PD Modification Application: PRS 23-0502

Hillsborough County Florida

Development Services Department

AGENCY REVIEW COMMENT SHEET

2.4 Proposed Site Plan (partial provided below for size and orientation purposes. See Section 8.2 for full site plan)

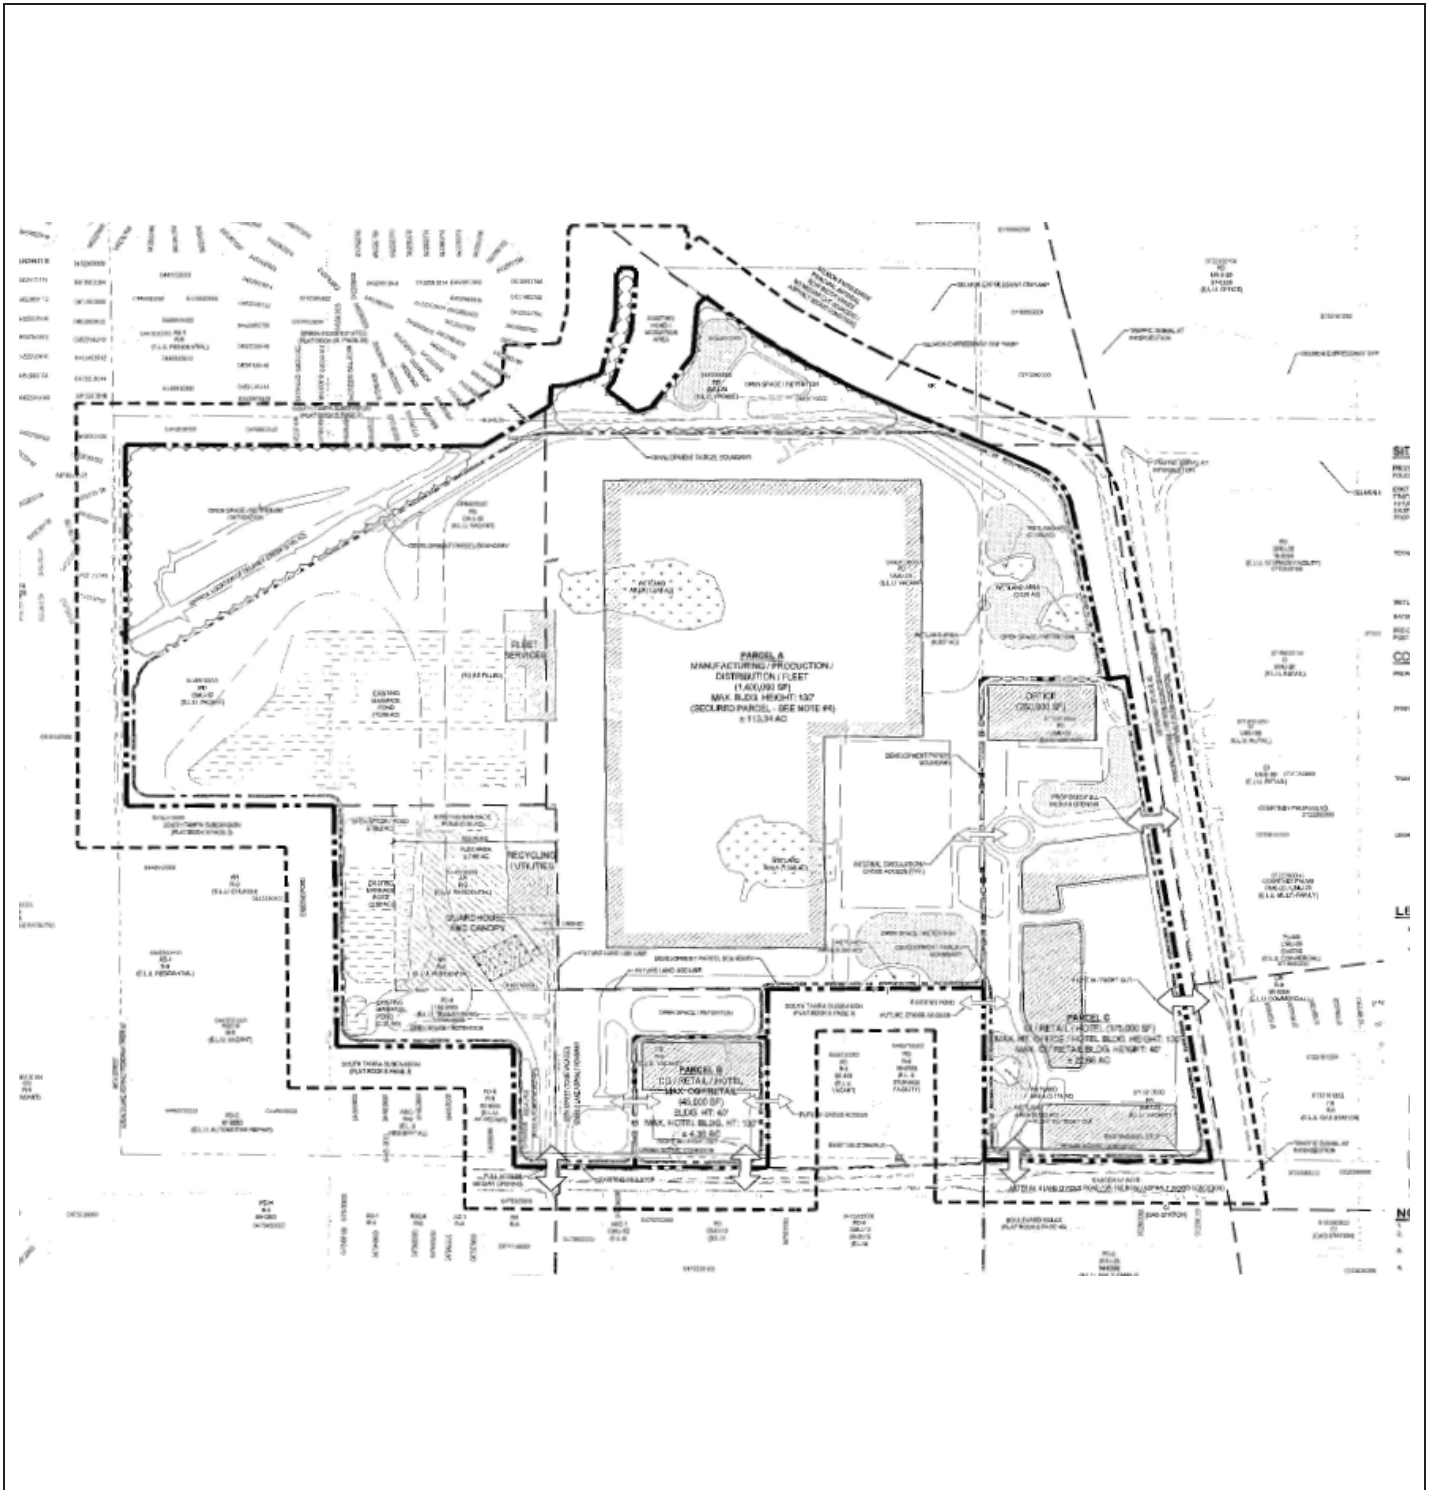
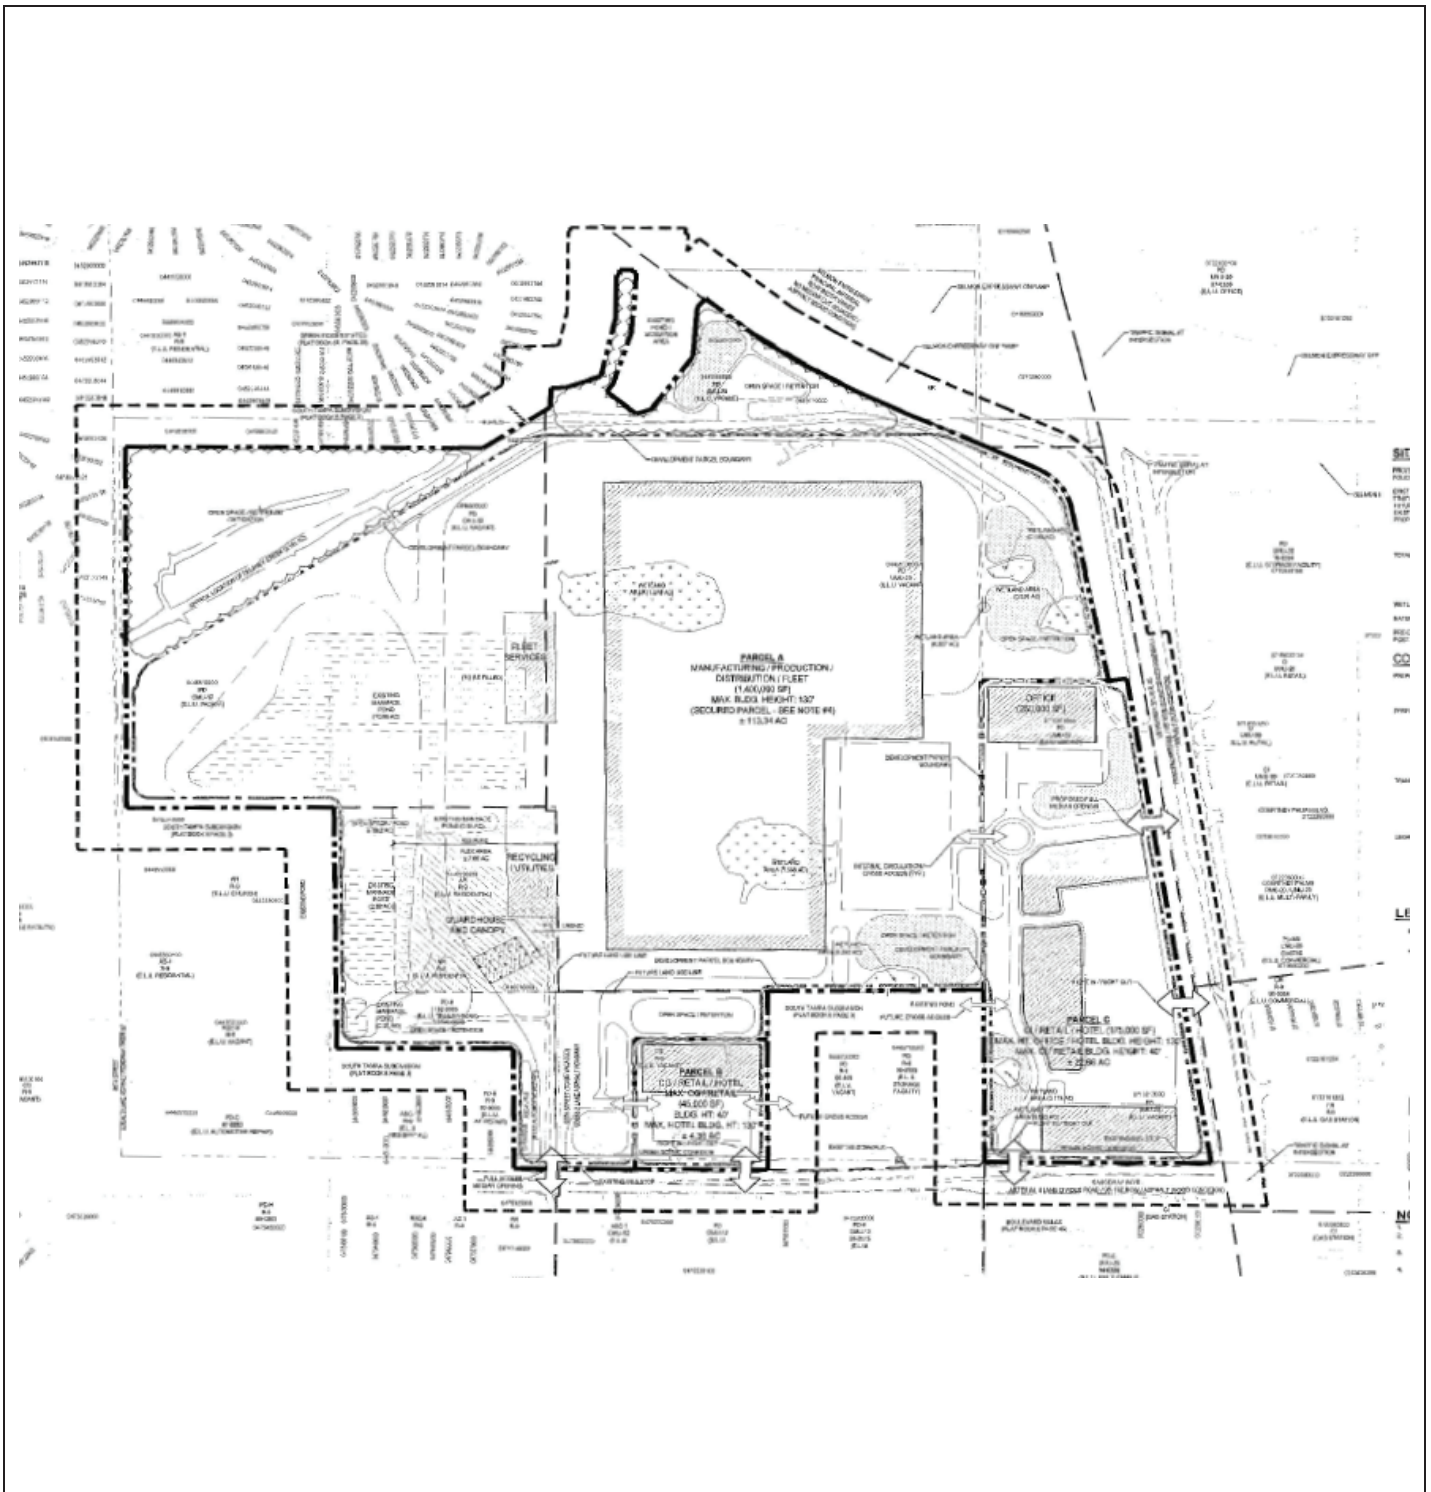
The subject site is zoned PD 19-1445 and approved for 1,870,000 sf for a mixed use project consisting of manufacturing, processing, distribution, commercial, office and hotel uses. The PD was approved with a flex of the UMU-20 FLU category. The applicant requests a modification to remove a sidewalk requirement and to remove FAR references. No square footage or use changes are proposed.

| Existing Approval(s): | Proposed Modification(s): |
|---|---|
| Developer to construct a minimum 5 foot wide sidewalk along the entirety of the project's US Hwy 301 and South 86 th Street frontages. | Developer to construct a minimum 5 foot wide sidewalk along the entirety of the project's US Hwy 301 frontage only. No sidewalk construction along South 86 th Street. |

The applicant states that providing the sidewalk is difficult due to existing conditions and necessary related improvements. Existing drainage swales limit the ability to provide the sidewalk adjacent to the roadway. To improve the roadway drainage, from the existing drainage swales, it will require a complete rebuilding of the roadway pavement section, the addition of an underground stormwater conveyance system, and the installation of concrete curbing. The alternative of providing the sidewalk further into the property, on the other side of drainage swale, would place the sidewalk on private property and the removal of existing oak trees.

Should the sidewalk be provided, it would need to cross Delany Creek, which has insufficient width to provide the sidewalk. Therefore, a separate pedestrian bridge would be needed. The pedestrian bridge would need to be designed in a manner that would not impede the creek's flow or decrease the floodplain storage volume. This would prohibit the use of piers and instead require the construction of a metal bridge section. Construction of such a bridge would require the use of a large crane. The presence of overhead power lines and existing trees would pose safety concerns when operating the crane in this area.

Transportation staff has reviewed the request and applicant's justification and has no objections to removal of the sidewalk requirement.

17. The developer shall construct a minimum 5-foot-wide sidewalk along the entirety of the project's U.S. Highway 301 only and ~~South 86th Street~~. Subject to Hillsborough County and FDOT approval, a minimum 5-foot wide boardwalk may be permitted in lieu of the sidewalk along Highway 301 provided such facility meets ADA requirements.
